Service Bulletin

NUMBER: M20-138

Replacement Tail Truss Part No. 480007

M20, M20A - All Serial Numbers

FIG 1 - EMPENNAGE INSTALLATION

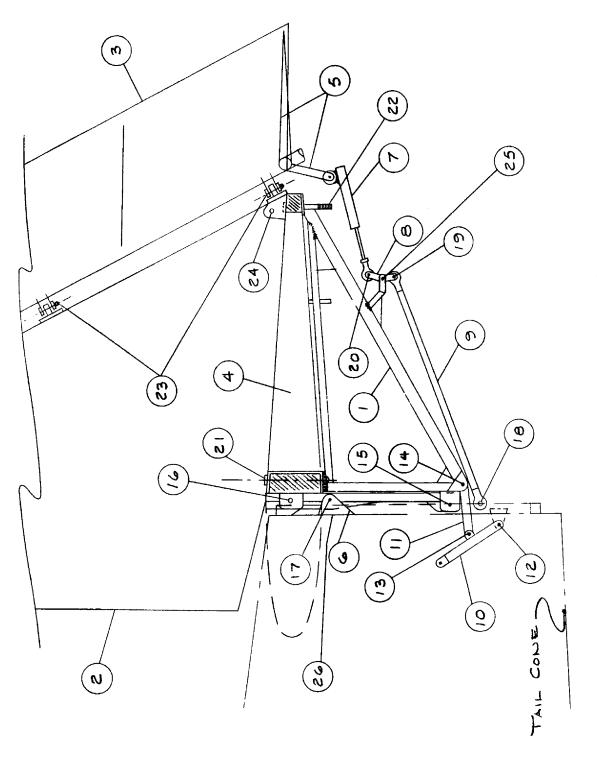
This service bulletin is issued to advise of the approval and availability of a new designed truss, Part No. 480007. By installing this truss on the above referenced aircraft, this will eliminate the requirements shown on Airworthiness Directive 65-22-3 issued September 16, 1965, and amendment effective November 4, 1965. The new truss should be inspected on each 100-hour or annual inspection in the same manner as all other structure.

- 4. Remove the upper attach bolts (item 17, fig. 1) and the lower bolt (item 14, fig. 1). Also disconnect the tube at the tail cone bulkhead (item 18, fig. 1) and remove the empennage carefully.

- 5. Exchange trusses and carefully inspect the bolts and bushings for excessive wear. Replace if wear is evident.
- 6. Install the empennage as previously installed. With the two upper empennage attach bolts installed, check the alignment of the 7108 link (item 11, fig. 1) with the U-fitting on the 480007 tail truss (item 14, fig. 1) as described in items 5 and 6 of the instructions in Mooney Service Bulletin 20-60 (formerly service letter).
